County of Loudoun

Department of Transportation and Capital Infrastructure

**SUBJECT: ZMAP 2012-0011 – Tuscarora Crossing
Third Referral**

Figure 6-4
2028 Intersection Levels of Service with Development

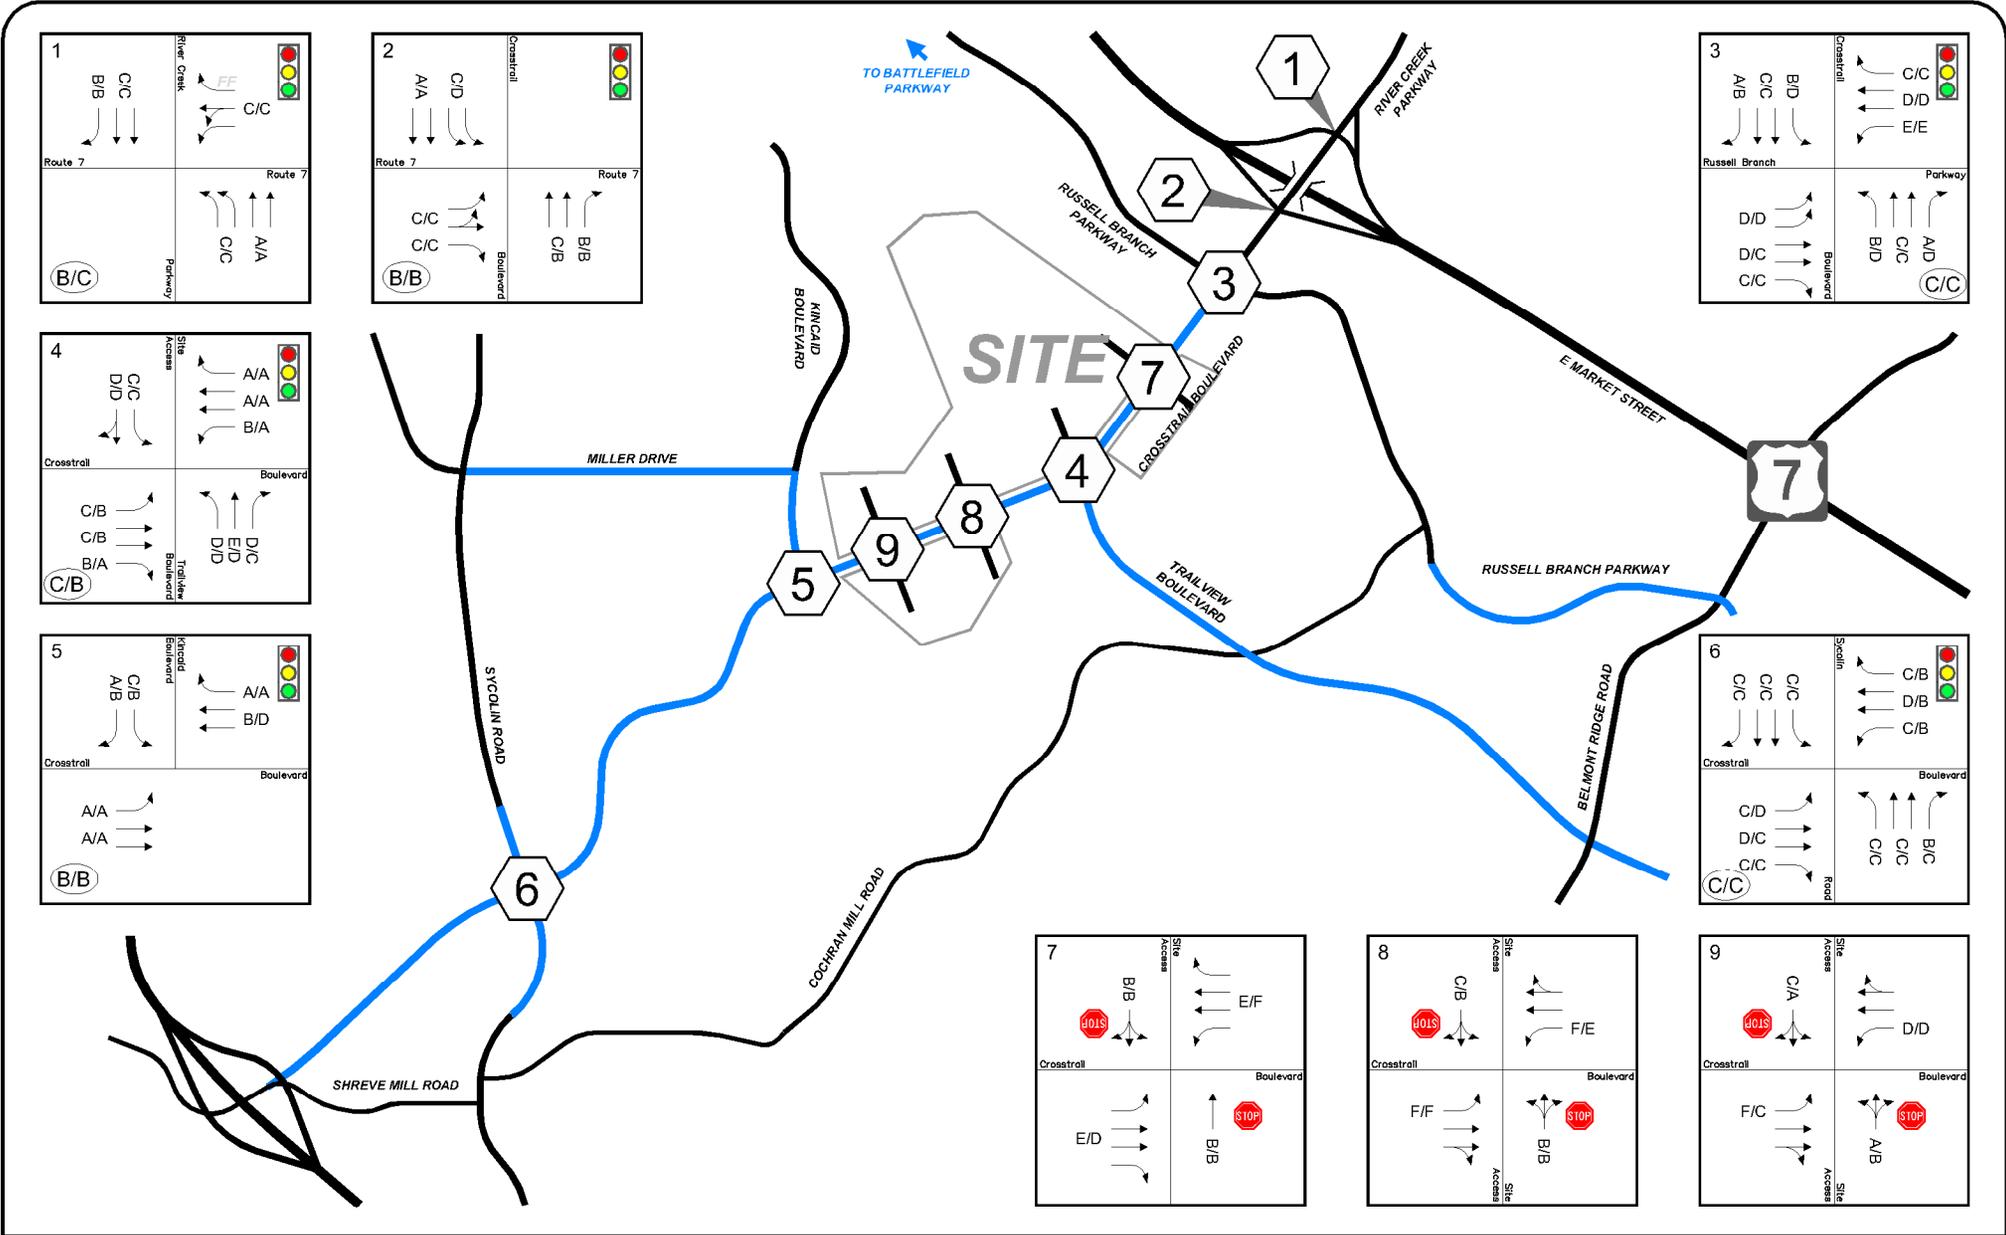
11. As per the revised traffic study, under the 2028 conditions with development, intersection #9 is stop controlled and the eastbound left-turn movement in the AM peak hour has a LOS F (Figure 6-4). Subsequently, Table 6-1 shows that under the 2028 conditions with development and improvements, the same movement has an LOS E in the AM peak hour.

DTCI requests the Applicant to clarify what improvements are causing the level of service to improve from F to E. Notwithstanding that, the 2010 CTP (*Chapter 2, LOS Standards Policies*) states that land development will only occur along roads or near affected intersections that currently function at LOS D, or which are forecast to be improved to LOS D as part of the application being considered. As such, the Applicant should commit to making necessary improvements. DTIC also acknowledges draft proffer IV.A.6, where the Applicant commits to conducting a traffic signal warrant analysis and subsequently construct a signal if warranted at the intersection of Crosstrail Boulevard and Land Bay 3. DTIC requests further clarification as to whether this draft proffer includes signalization of both intersections #8 and #9. If so, the traffic study should be revised to analyze both intersections under signalized conditions.
